THE COUNTY OF LENNOX & ADDINGTON

CONTRACT No. 24073

LOYALIST AMBULANCE BASE

ADDENDUM #3

SITE PLAN

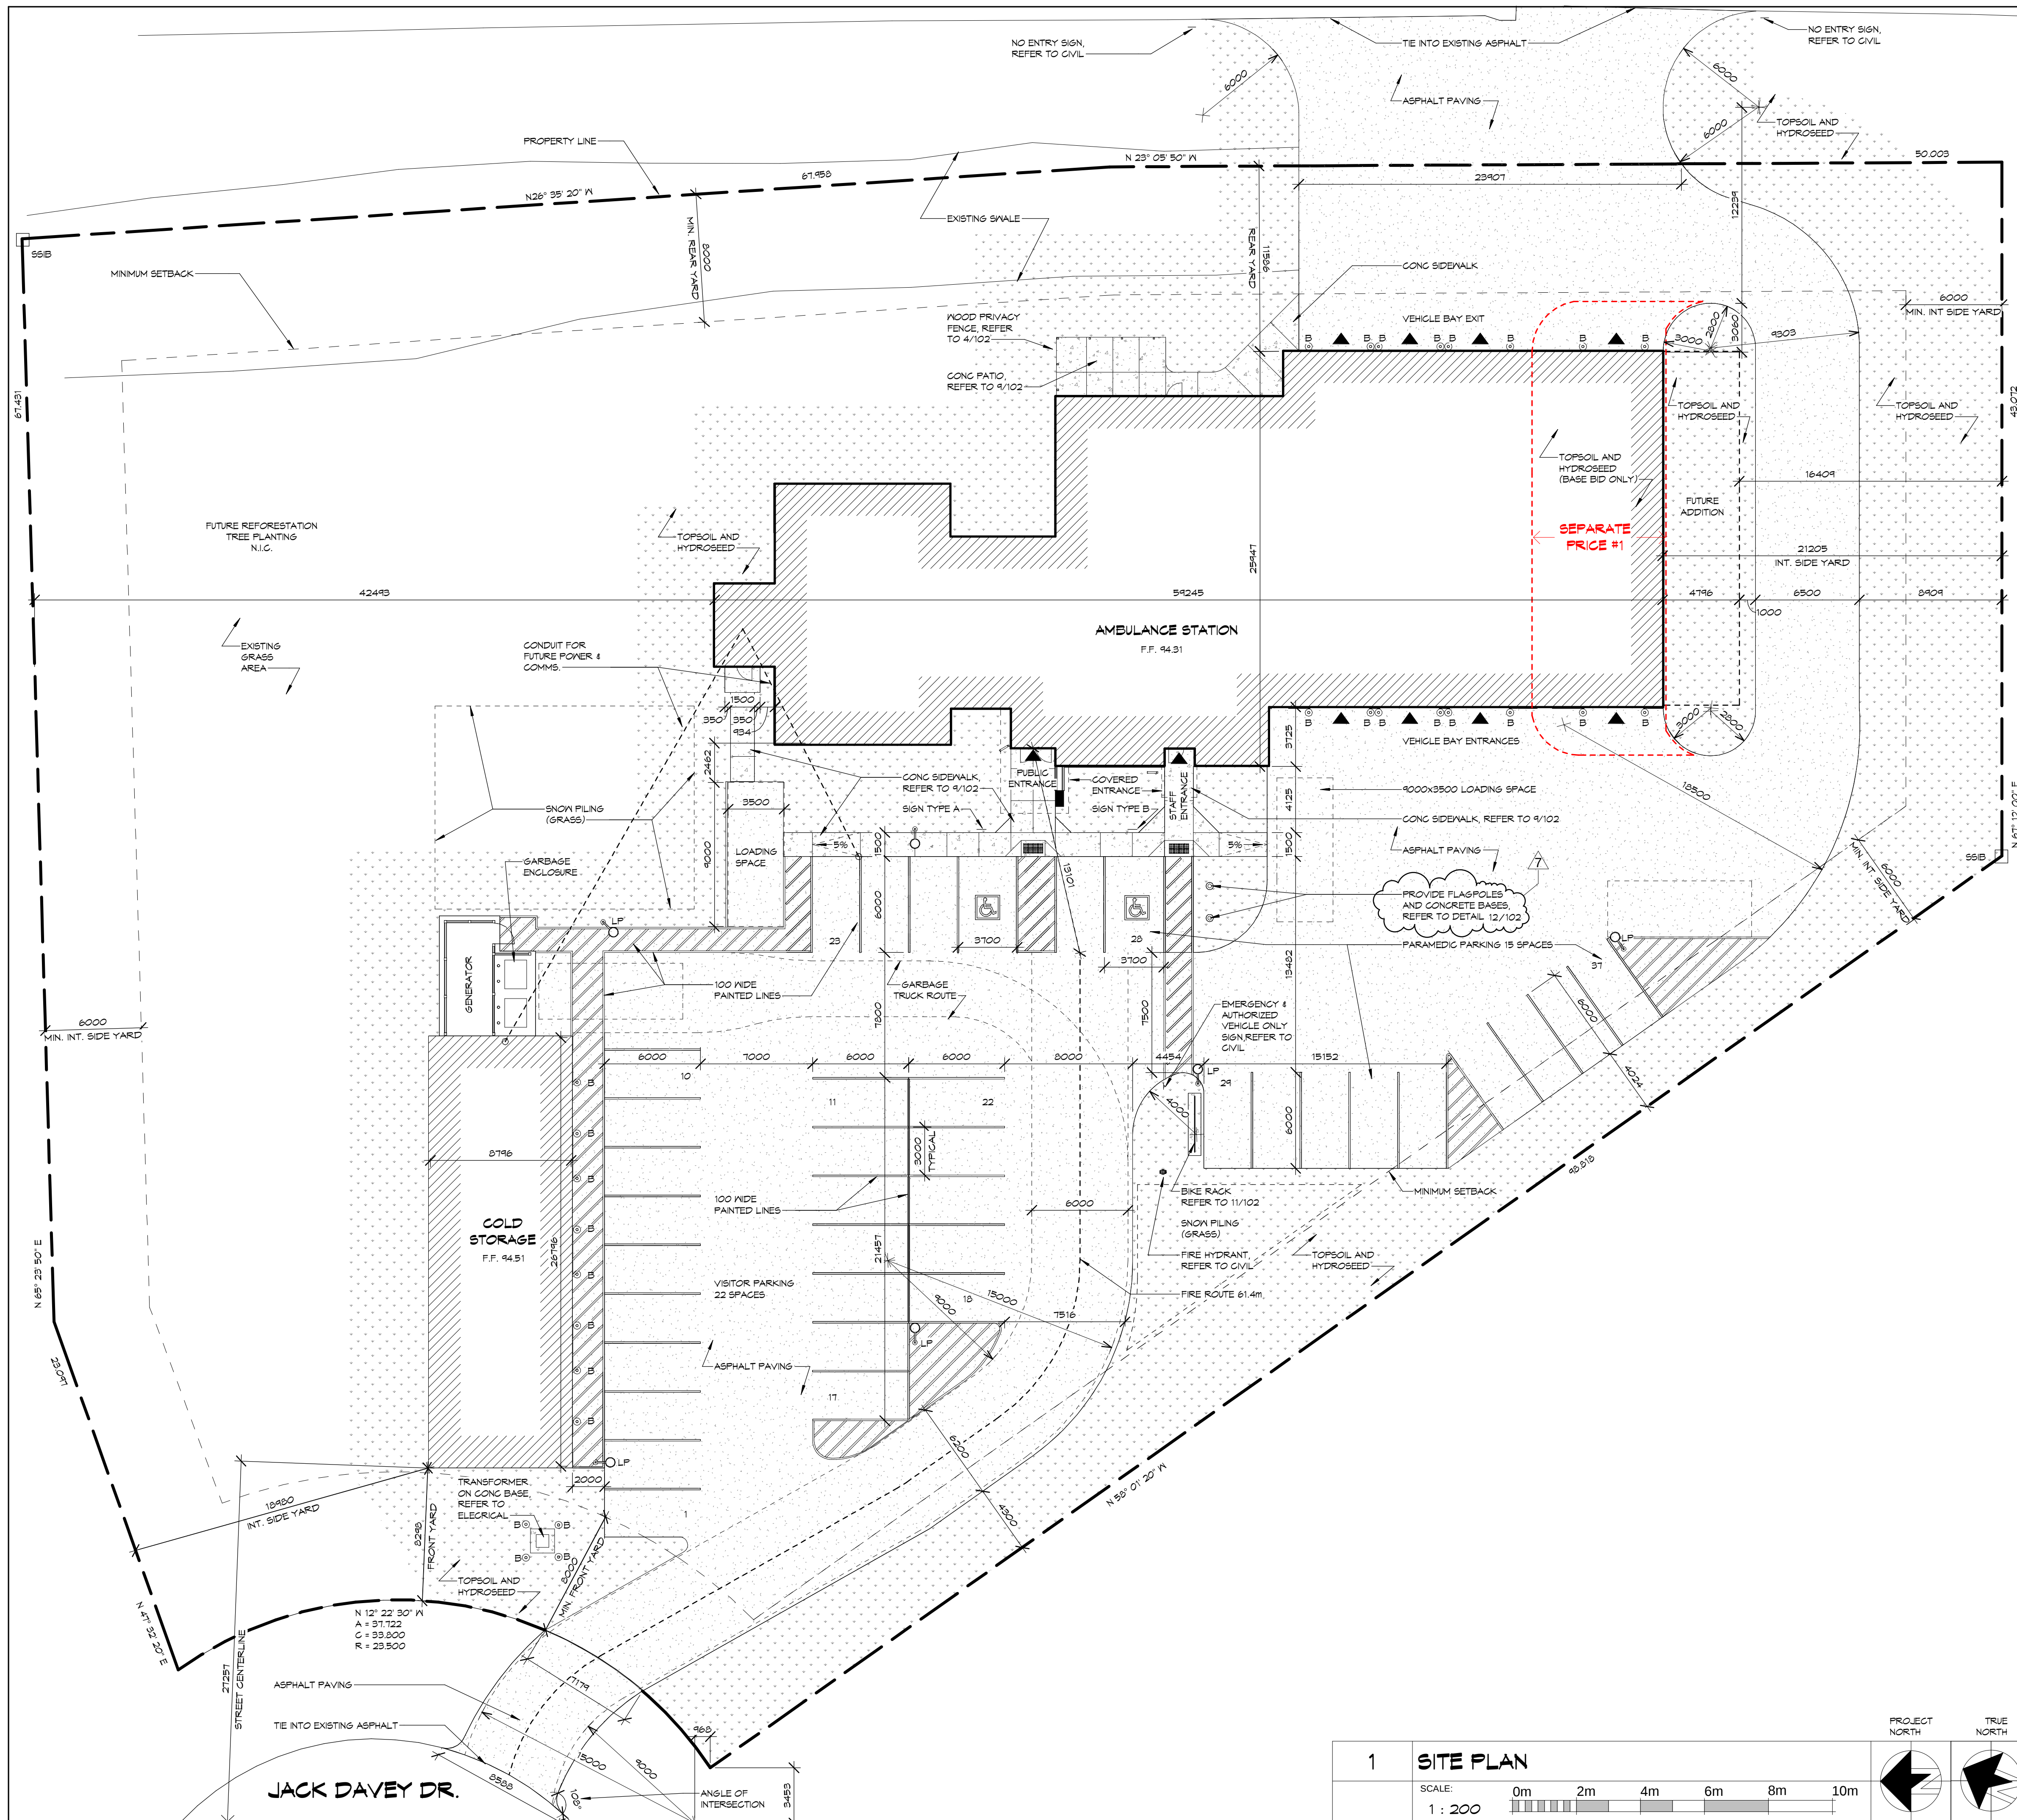
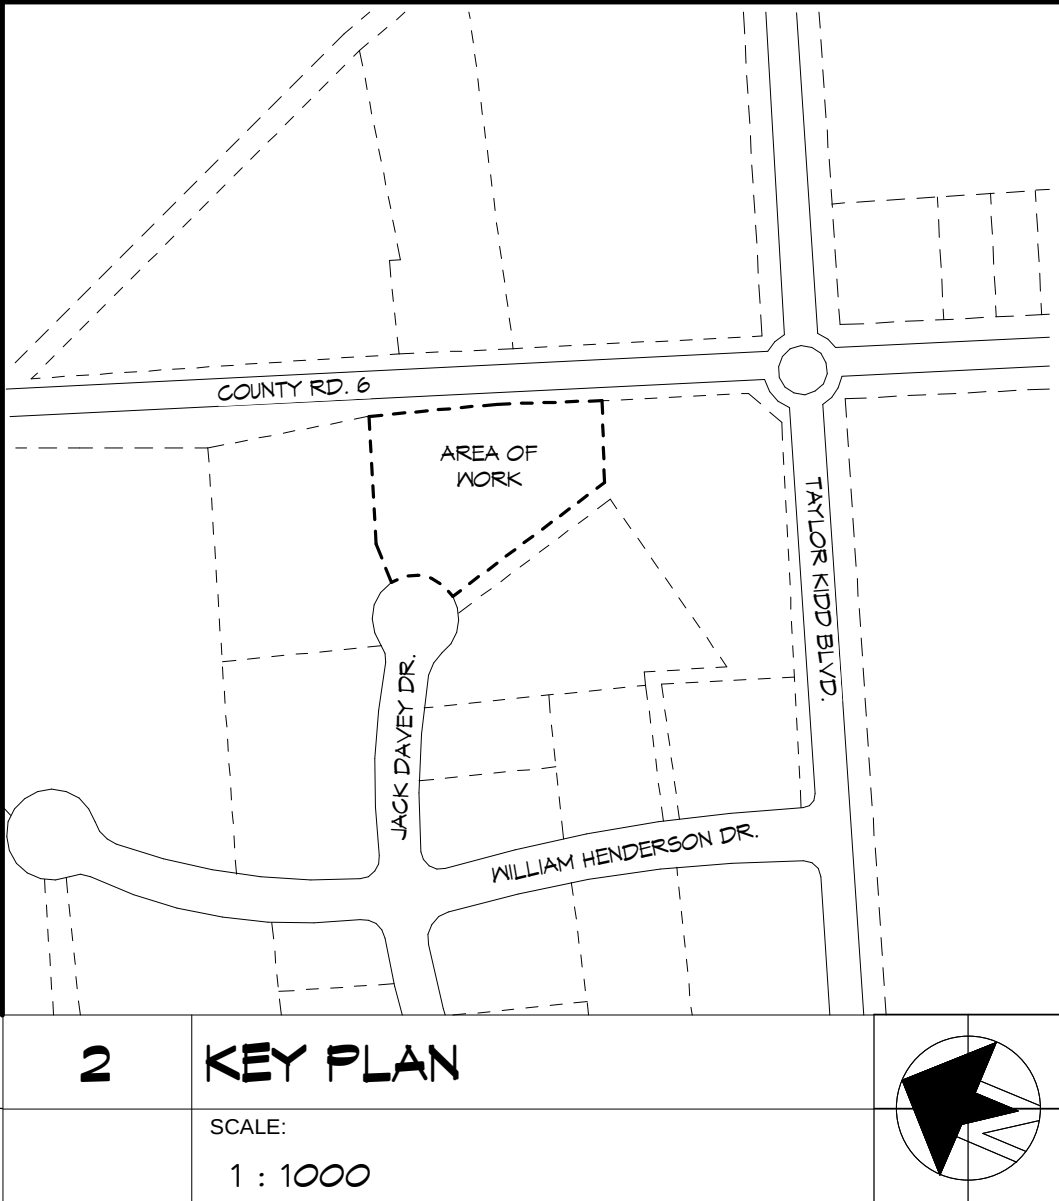
Q1: A flagpole is noted in the details of the project documents but not on the site plan. Is a flagpole to be included for by the general contractor?

A1: Flagpole is to be included, see revised DWG 101 Site Plan and 10 75 00 flagpole specification included with this addendum. For the roofing system, bid as tendered.
